LR-N12-0068
February 23, 2012

Salem Nuclear Generating Station, Units 1 and 2
Renewed Facility Operating License Nos. DPR-70 and DPR-75
NRC Docket Nos. 50-272 and 50-311

Hope Creek Generating Station
Renewed Facility Operating License No. NPF-57
NRC Docket No. 50-354

Subject: Emergency Plan Document Revisions Implemented January 25, 2012

FIGURE 4-1
SALEM and HOPE CREEK GENERATING STATIONS
ACCESS FROM AREA AIRPORTS

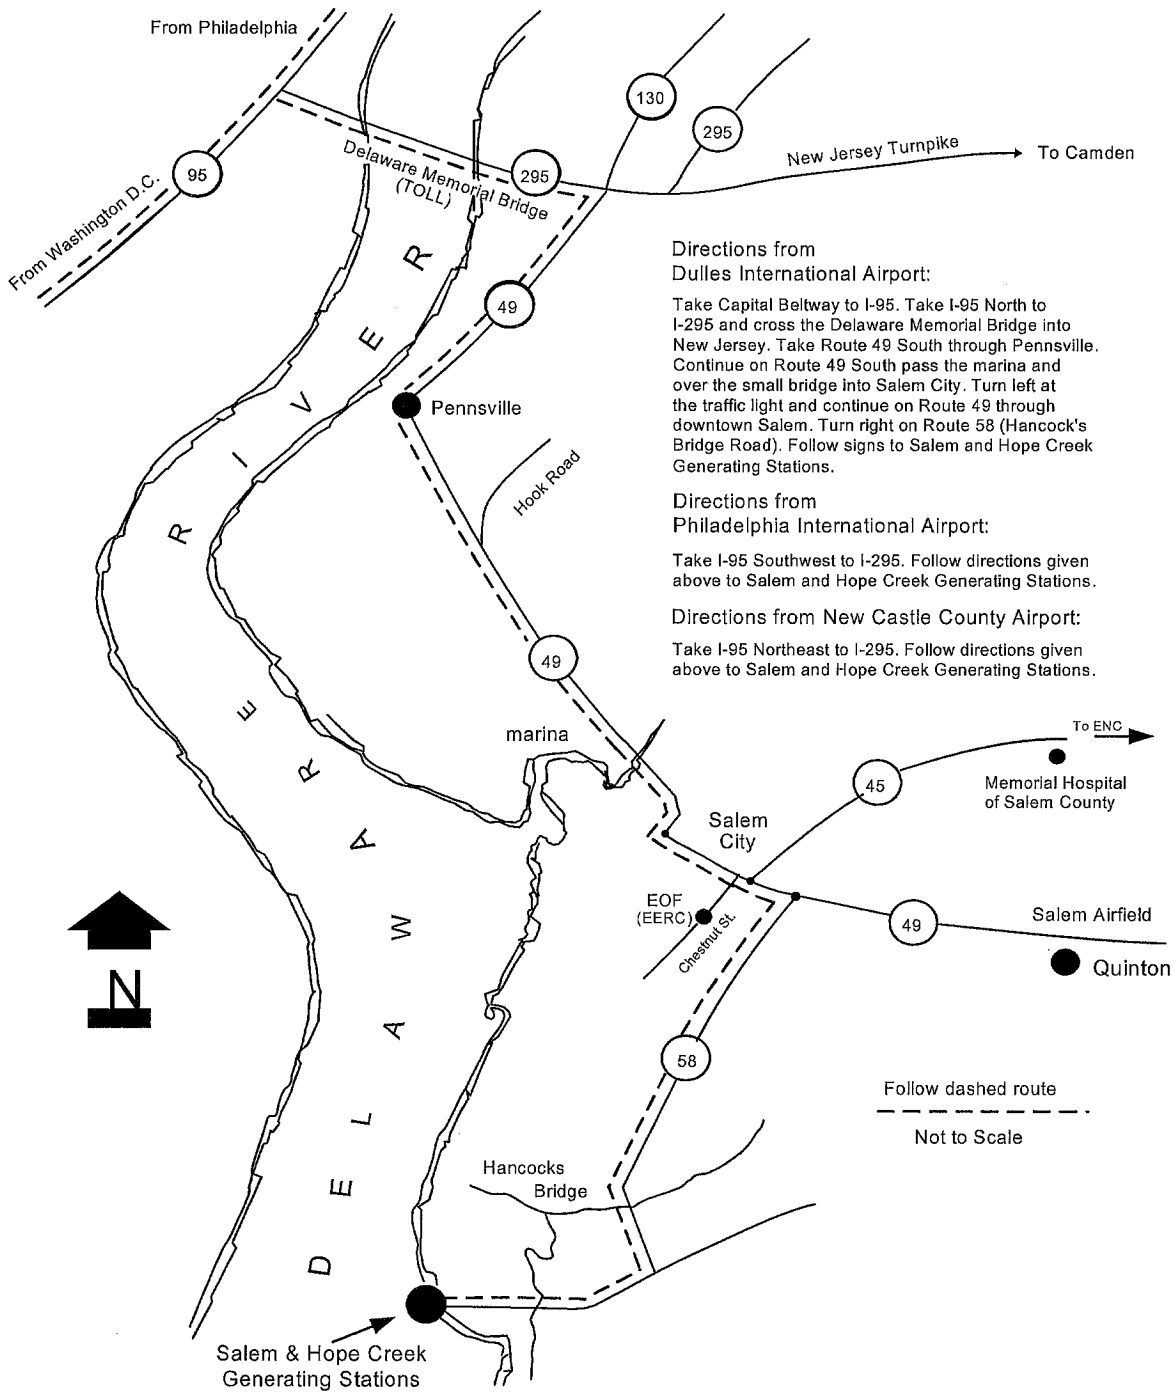
Editorial: Corrected Typo in section 1.2 and clarified map in Figure 4-1

Editorial: Corrected Typo in section 1.2 and clarified map in Figure 4-1
